ADDENDUM #3

Re: Harrisburg Area Community College

RLAC Theater and Prototype Toilet Room Renovations

Solicitation #RFB15-10

+ 9' - 0"

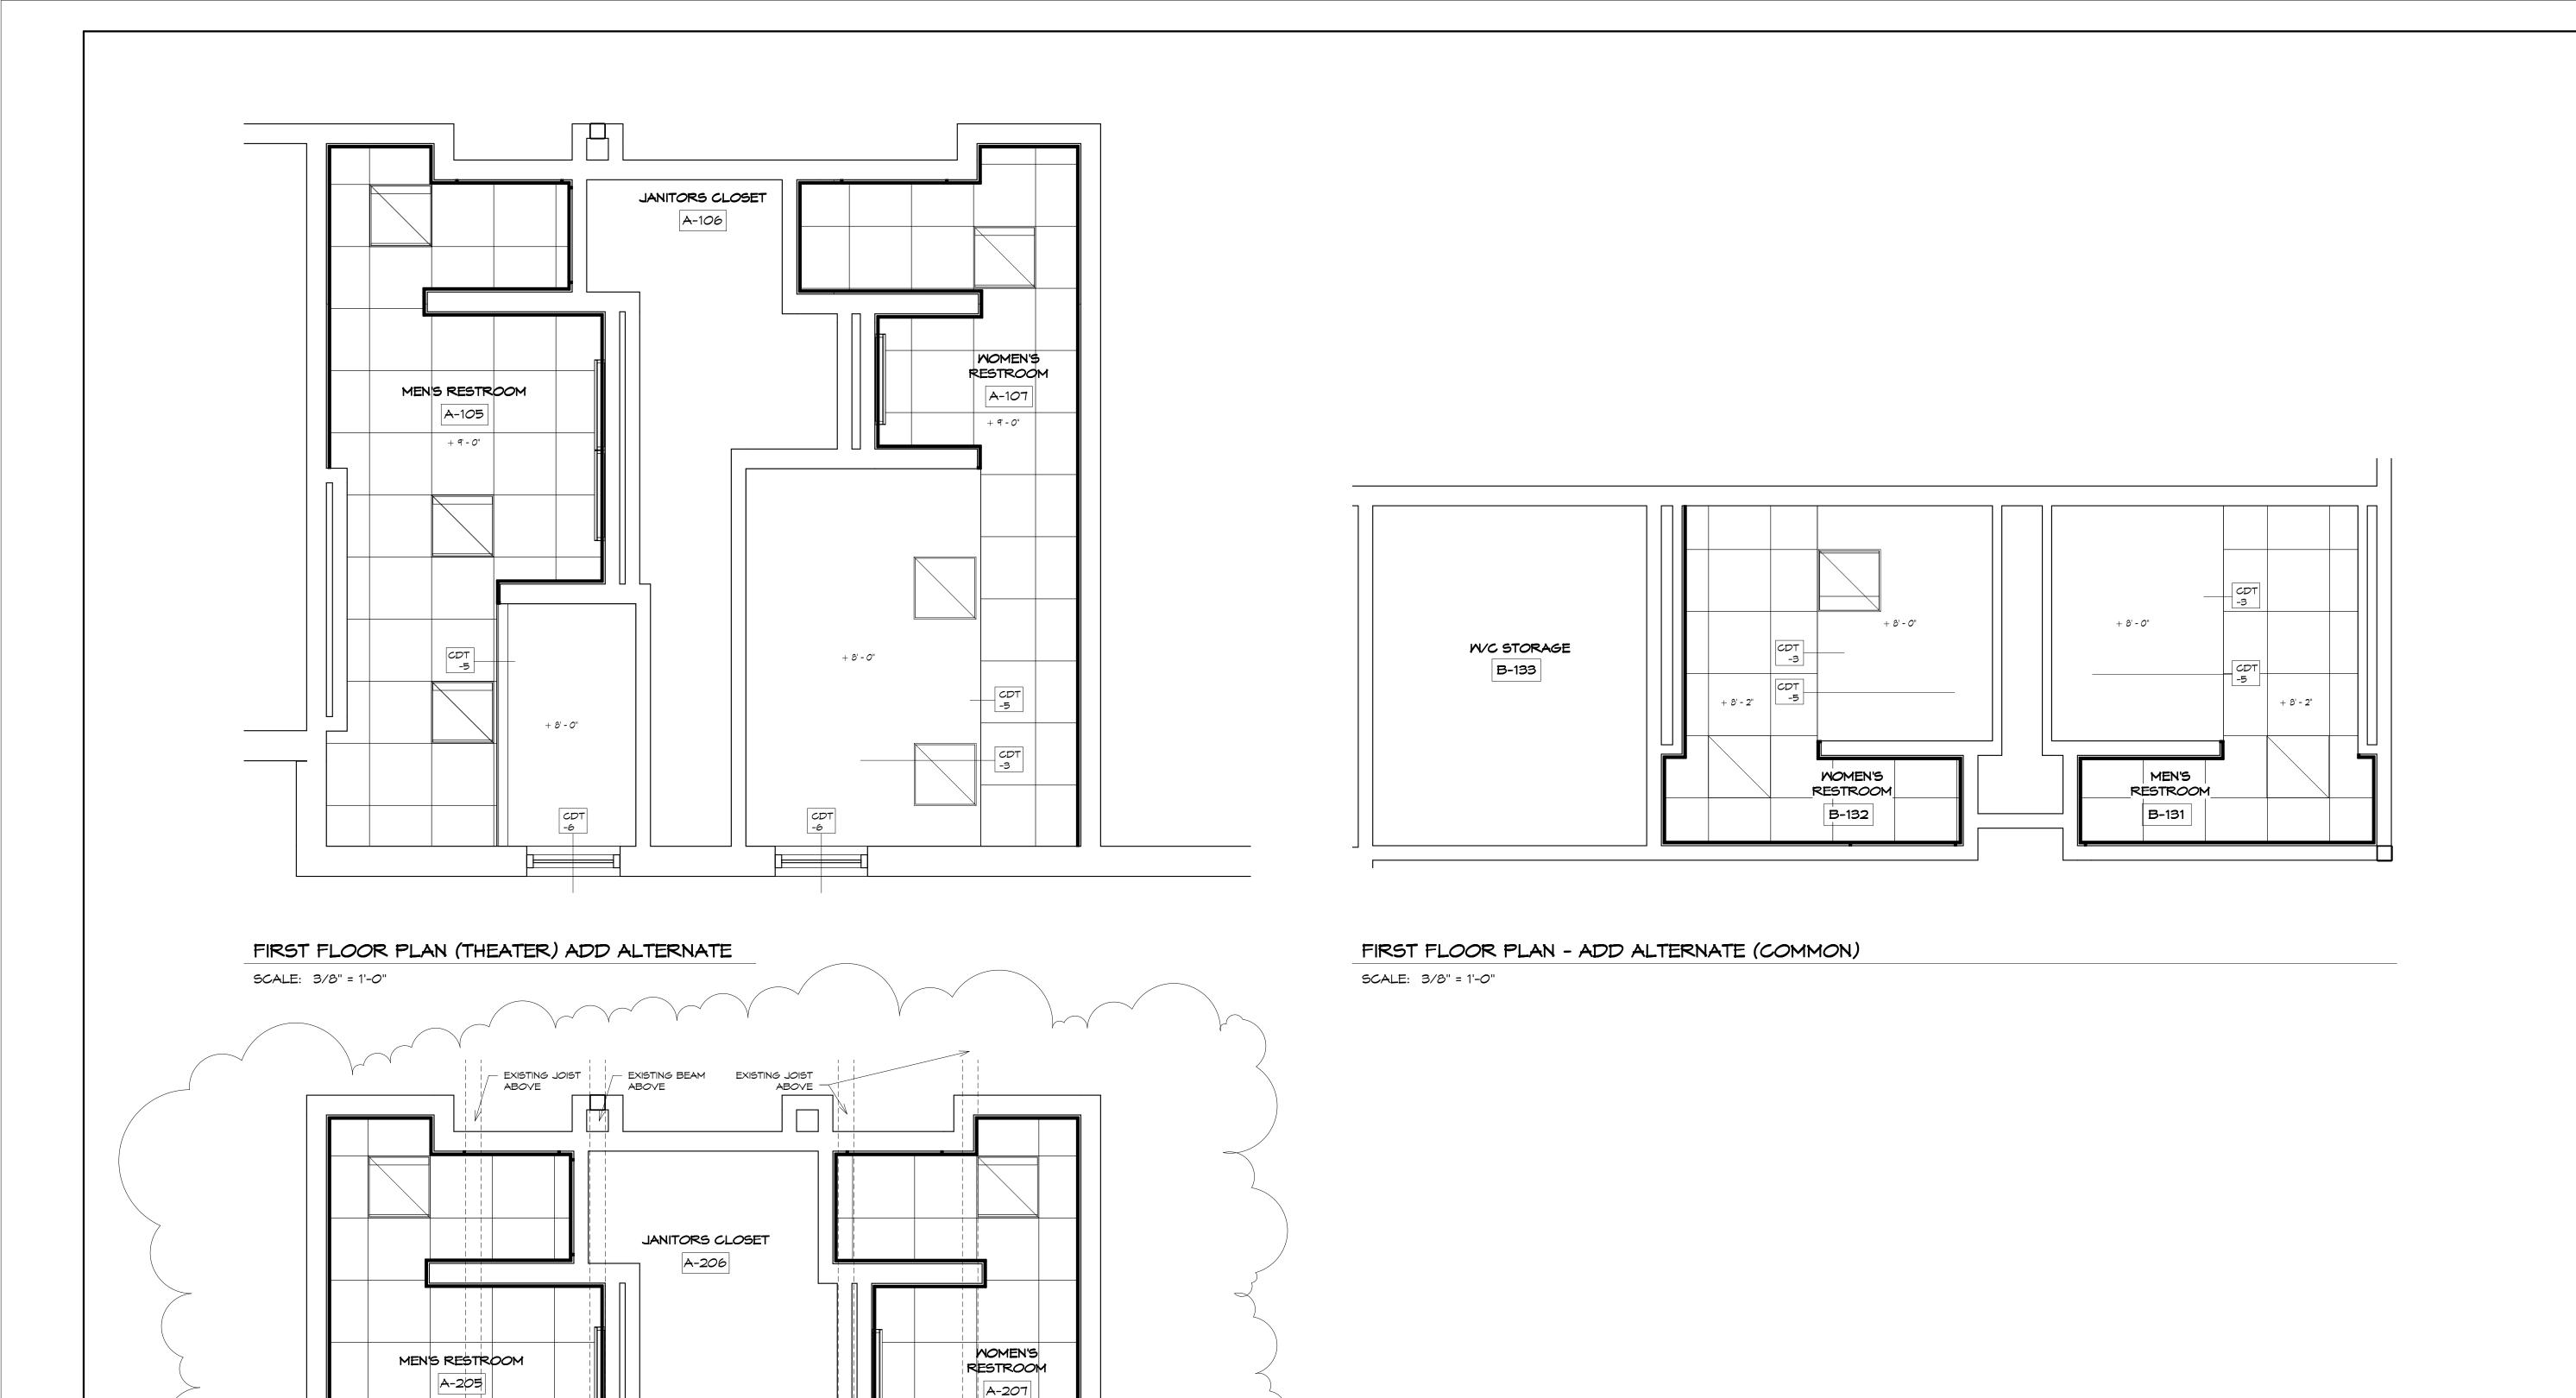
- INSTALL 3" X 5" ANGLE BETWEEN JOISTS. WELD BOTH ENDS

INSTALL 3" X 5" ANGLE BETWEEN
JOISTS. WELD BOTH ENDS
